VIRGINIA ELECTRIC AND POWER COMPANY
SUBMITTAL OF APPROVED TOPICAL REPORT DOM-NAF-1-REV. 0.0-P-A
QUALIFICATION OF THE STUDSVIK CORE MANAGEMENT SYSTEM REACTOR
PHYSICS METHODS FOR APPLICATION TO NORTH ANNA AND SURRY POWER
STATIONS

**Qualification of the Studsvik
Core Management System
Reactor Physics Methods for
Application to North Anna
and Surry Power Stations**

Appendix A: RAI Set 1 Questions and Responses**NRC Request for Additional Information (first set) and Responses**

Figure 22

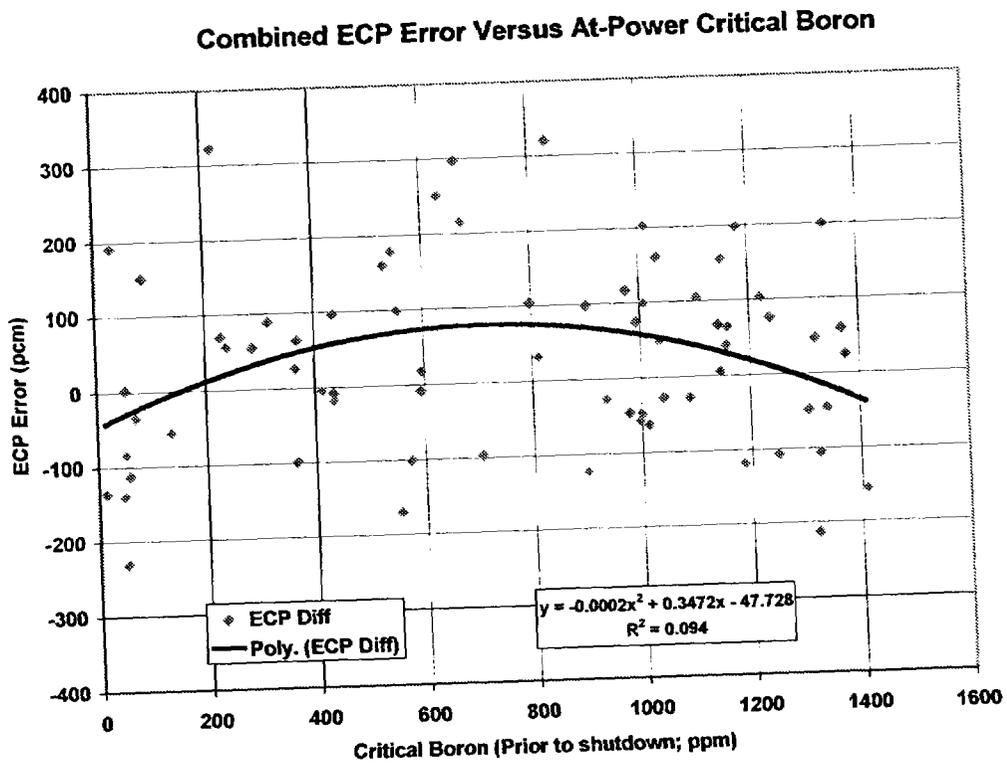
- 7) Figure 22 on page 54 shows significant scatter. Please explain how this data supports your statement that the bias is primarily in the middle of the boron range.

Figure 22 was not intended to demonstrate a strong correlation between boron concentration and ECP error. In fact, no correlation with boron is expected except that which results from the mis-modeling of ECP conditions due to B^{10} depletion. Figure 22 was included to show that a portion of the ECP data scatter is probably due to B^{10} depletion rather than SIMULATE uncertainty. However, for simplicity, all of the data have been included in the determination of the ECP statistics in Table 10.

B^{10} depletion introduces mis-modeling because the measured boron before the ECP can have a different B^{10}/B^{11} ratio than the measured boron at the time of the ECP return to critical. SIMULATE boron predictions are based on a constant B^{10}/B^{11} ratio. The reactivity comparison between measurement and prediction is skewed by the B^{10}/B^{11} difference. Although it is possible to correct for this mismatch, the process involves a great deal of measured data and was not practical due to the large number of cycles modeled.

B^{10} depletion mis-modeling is most likely to occur at mid cycle, during which boron concentration tends to be in the middle of the range shown in Figure 22. The bow in the fit is consistent with the expected influence of uncorrected B^{10} depletion on an ECP. The point in demonstrating this is to show that B^{10} depletion tends to increase the scatter in the ECP data (introduces a positive bias for certain cases but not for others)

N1C6 Power Transient Critical Boron Comparison

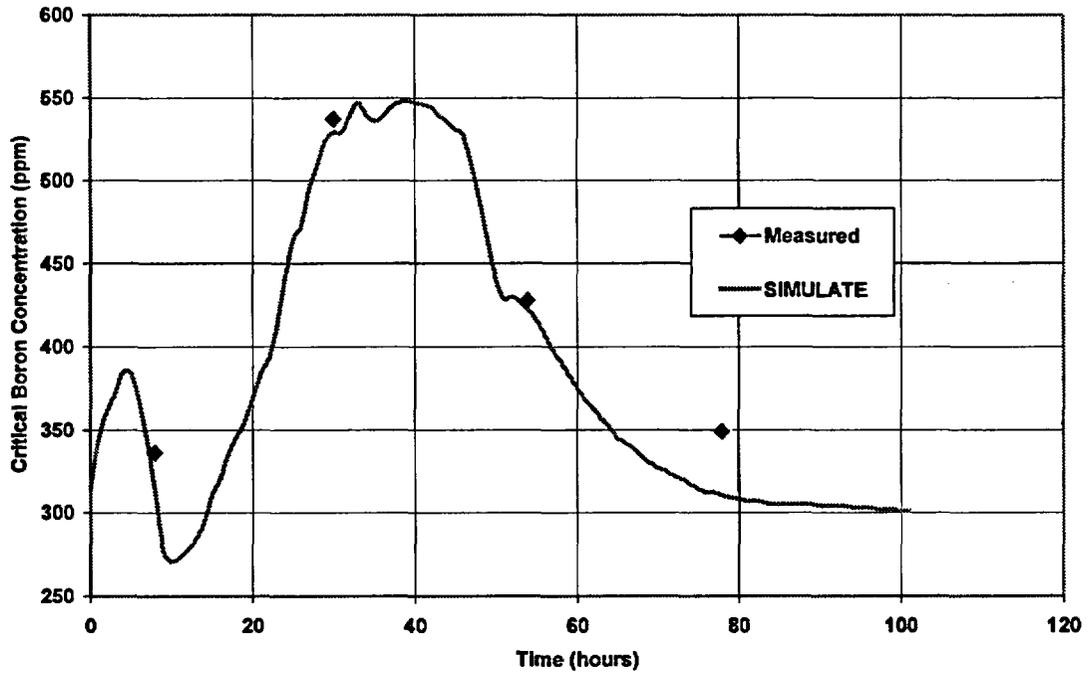
10) On page 75, you indicate that the Figure 38 SIMULATE boron values followed the measured values within about +18/-15 ppm. However, you only provide 4 data points for comparison purposes during the power transient. Describe how SIMULATE accurately models this transient given the limited data. Additionally, describe why the +18/-15 ppm assessment is accurate.

There are only four critical boron data points available for the N1C6 transient. The "+18/-15" comment indicates the range of difference (P-M) for those four points after accounting for the initial difference at the beginning of the transient. These results are consistent with the body of data from the other transients and consistent with the critical boron NRF. The good agreement between predicted and measured delta-I data is the best evidence of modeling accuracy for this transient.
